MODIFICATION APPLICATION

LEVEL 4 - SERVICE VEHICLE ZONE REVISED PLAN (PHASE A)

RPAC
26 ALBION STREET WAVERLEY NSW 2024

REVISED ELEVATION - EAST
STAGE 1 (PHASE A)

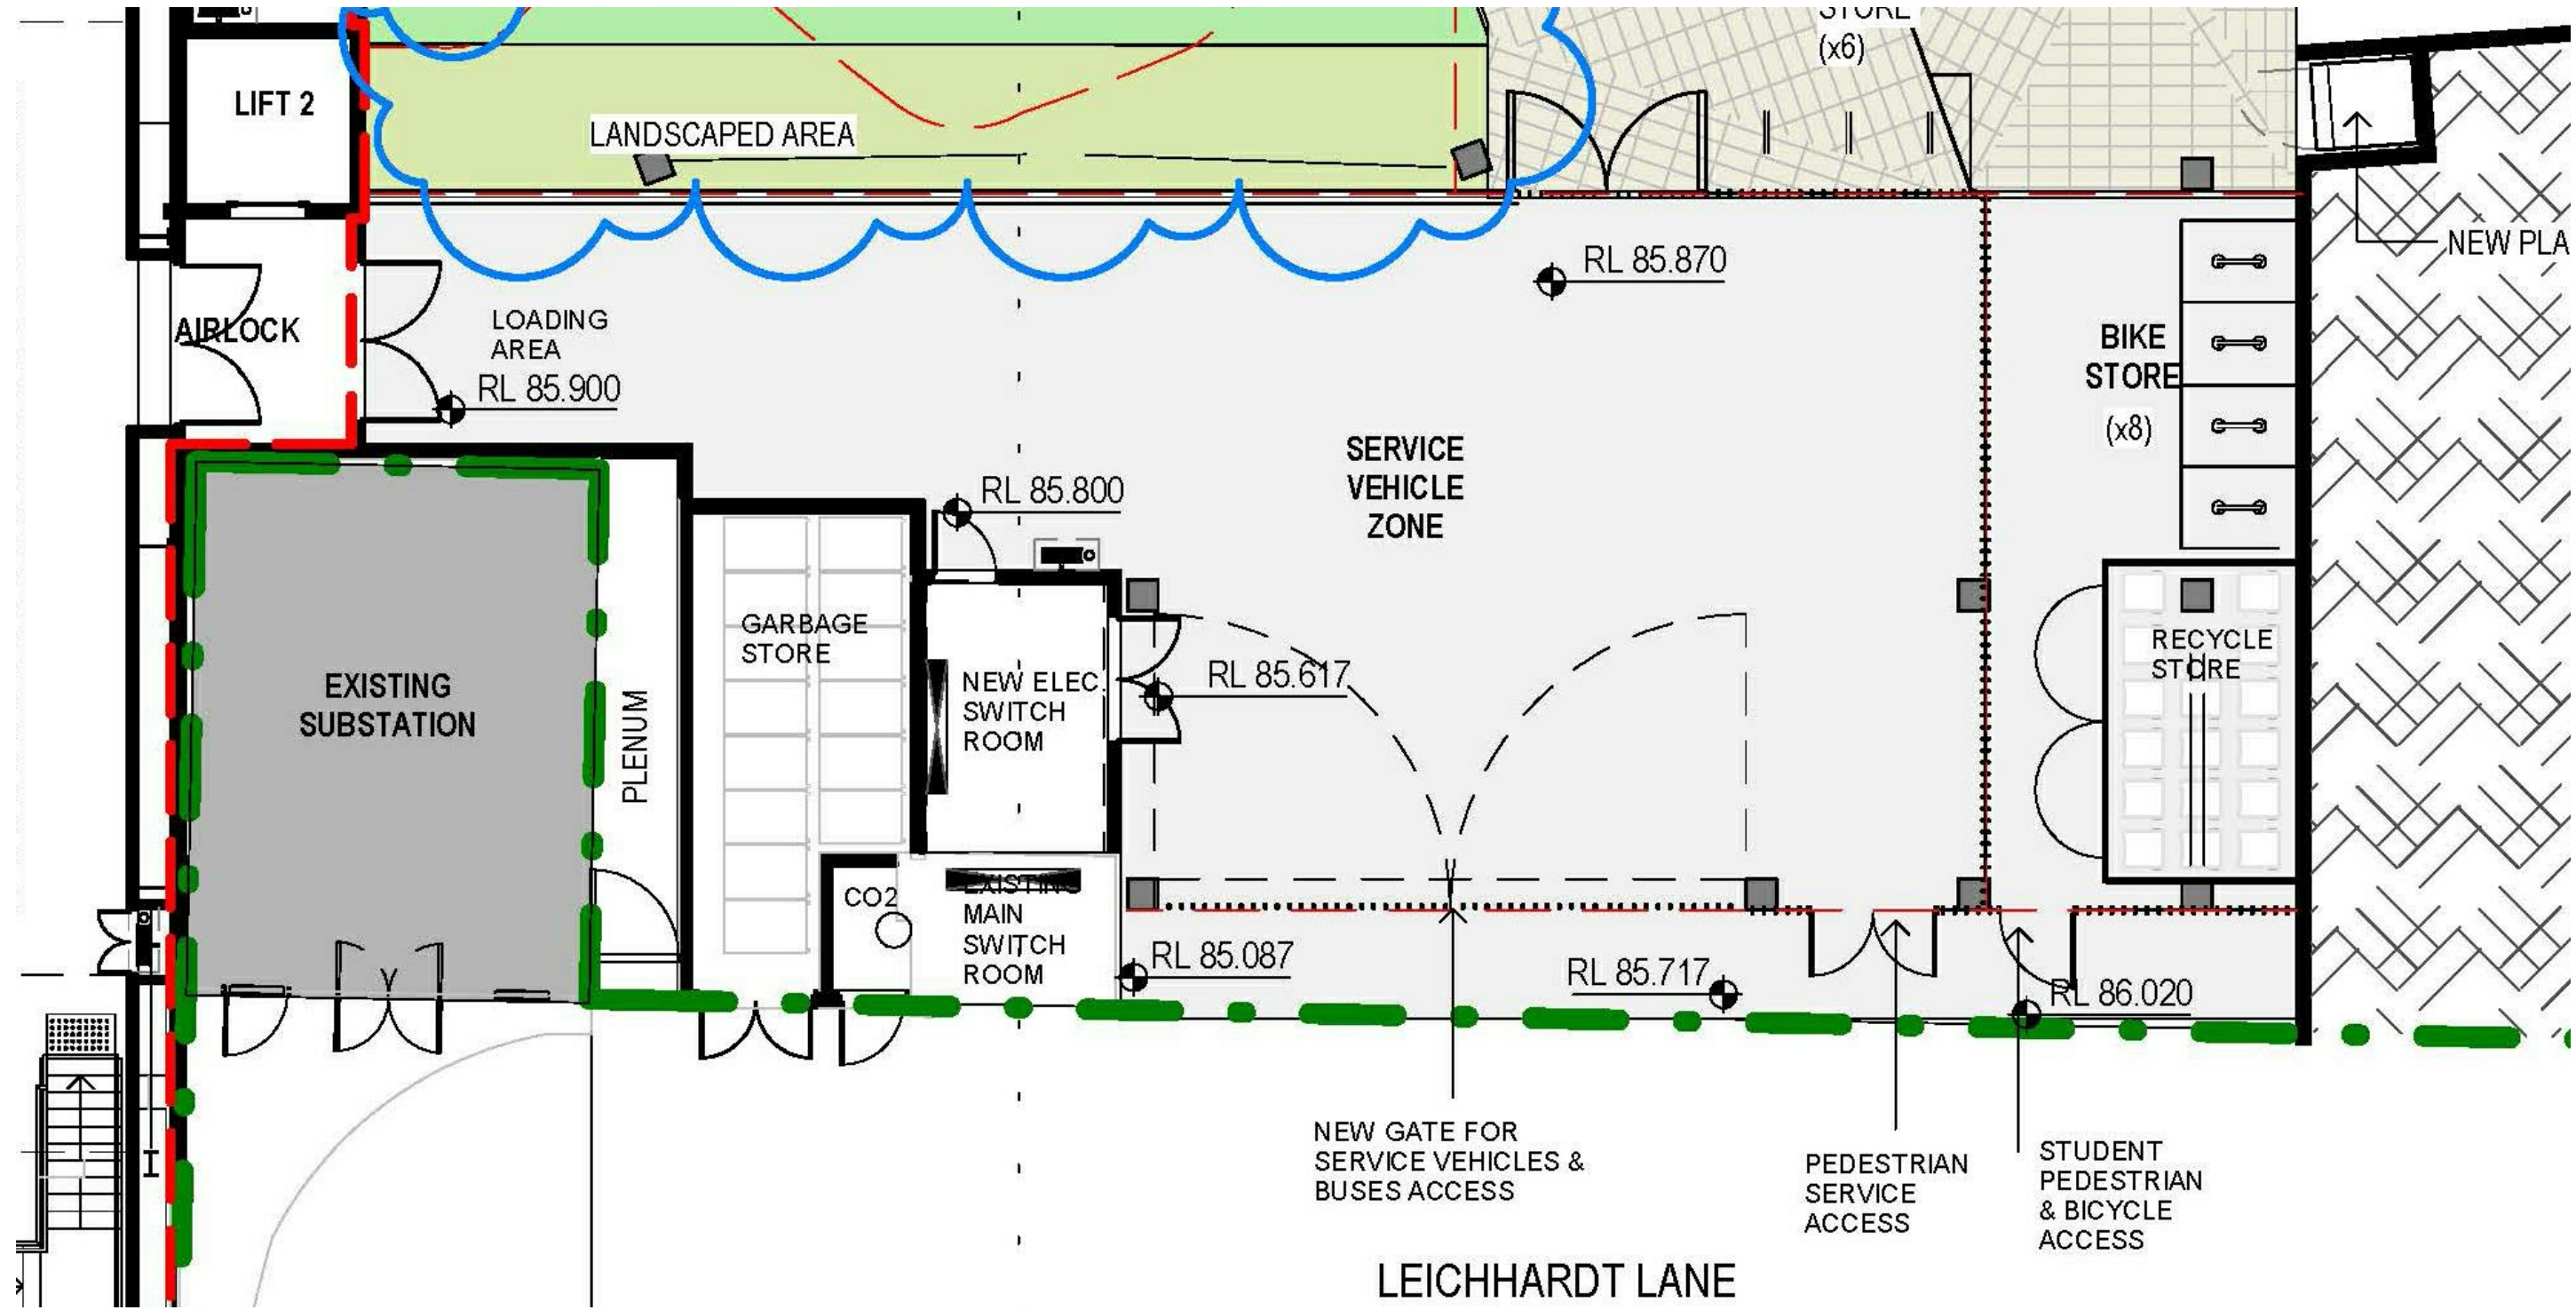
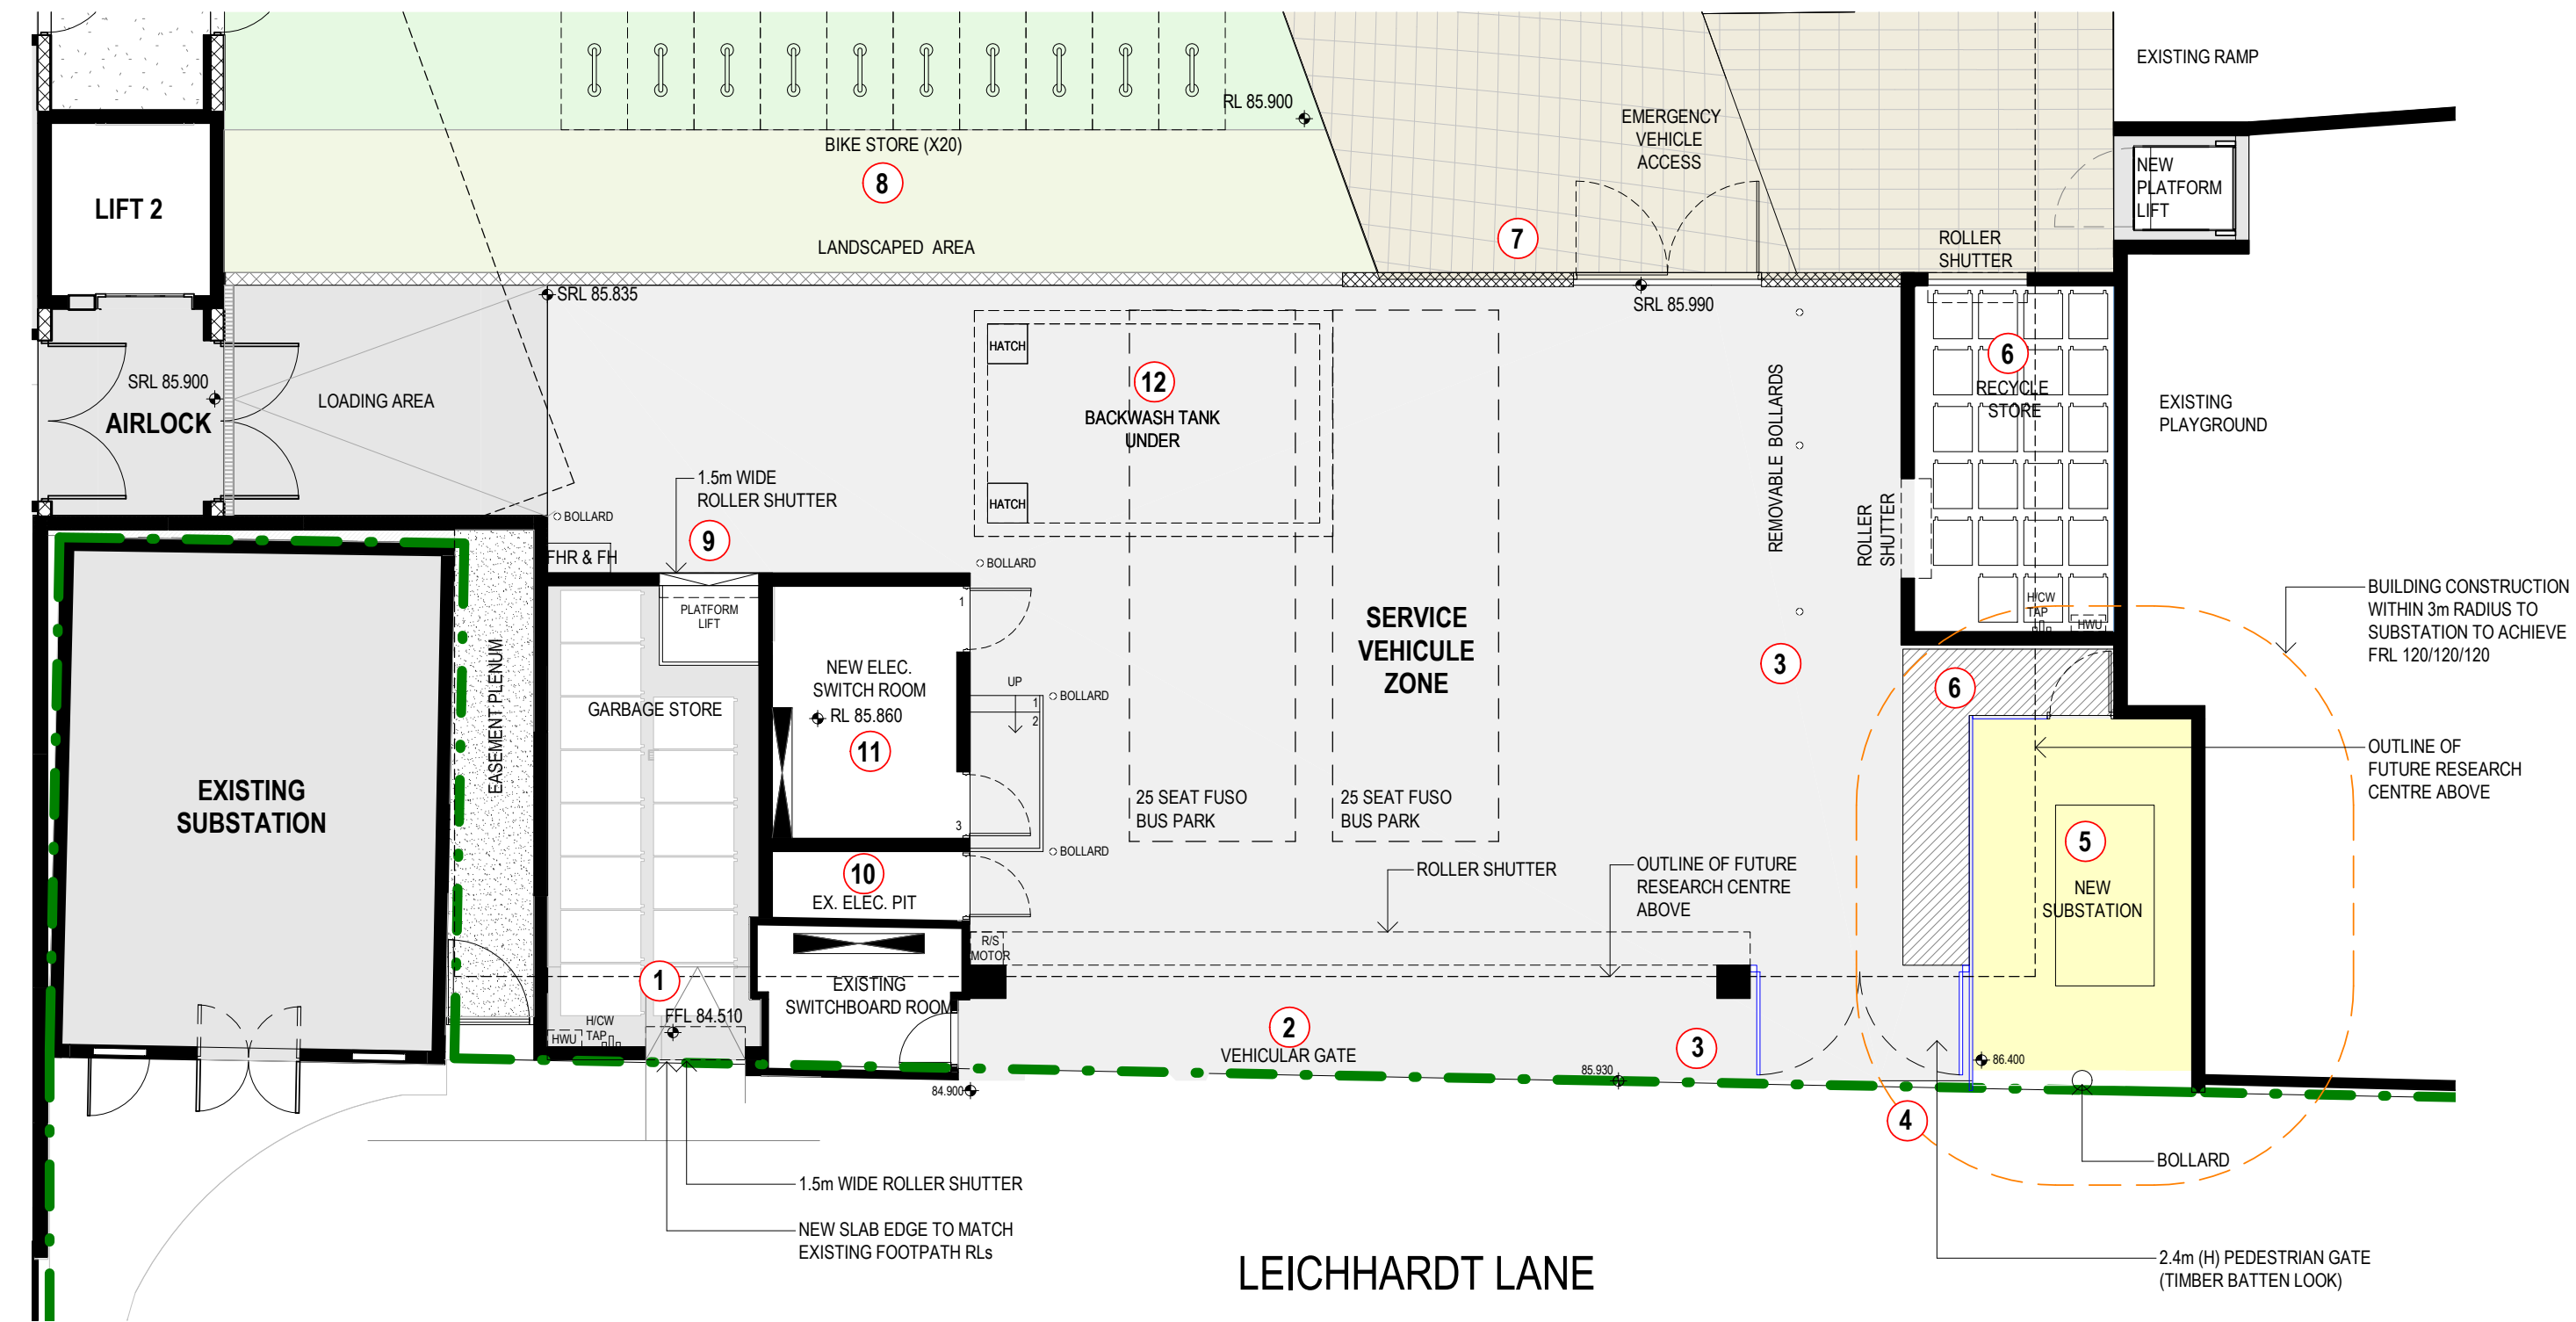
- LIST OF REVISED ITEMS:
1. CO2 ROOM DELETED AS NO LONGER REQUIRED.
 2. VEHICULAR GATE SWING DOORS REPLACED BY ROLLER SHUTTER FOR A MORE ADEQUATE AND SAFE CIRCULATION ENTRY/EXIT OF VEHICLES.

3. INTERNAL FENCE & ASSOCIATED GATE DELETED AS NO LONGER REQUIRED.
 4. PEDESTRIAN GATE RELOCATED FOR IMPROVED FUNCTIONALITY.
 5. NEW SUBSTATION RELOCATED FROM ALBION STREET TO LEICHHARDT LANE.

6. RECYCLE STORE RELOCATED FOR IMPROVED FACILITIES OPERATIONS FUNCTIONALITY.
 7. INTERNAL GATE ENLARGED AND RELOCATED FOR BETTER ACCESS OF EMERGENCY SERVICE VEHICLES.

8. BIKE STORE RELOCATED.
 9. NEW ACCESS POINT TO GARBAGE STORE IMPROVED FACILITIES OPERATIONS FUNCTIONALITY
 10. EXISTING ELECTRICAL PIT AREA TO REMAIN FOR SERVICEABILITY.

11. NEW ELECTRICAL SWITCH ROOM ENLARGED FOR COMPLIANCE. ACCESS STEPS PROVIDED TO SAVE LEVELS DIFFERENCE.
 12. UNDERGROUND BACKWASH TANK INCLUDED FOR WATER FILTRATION REQUIREMENTS.
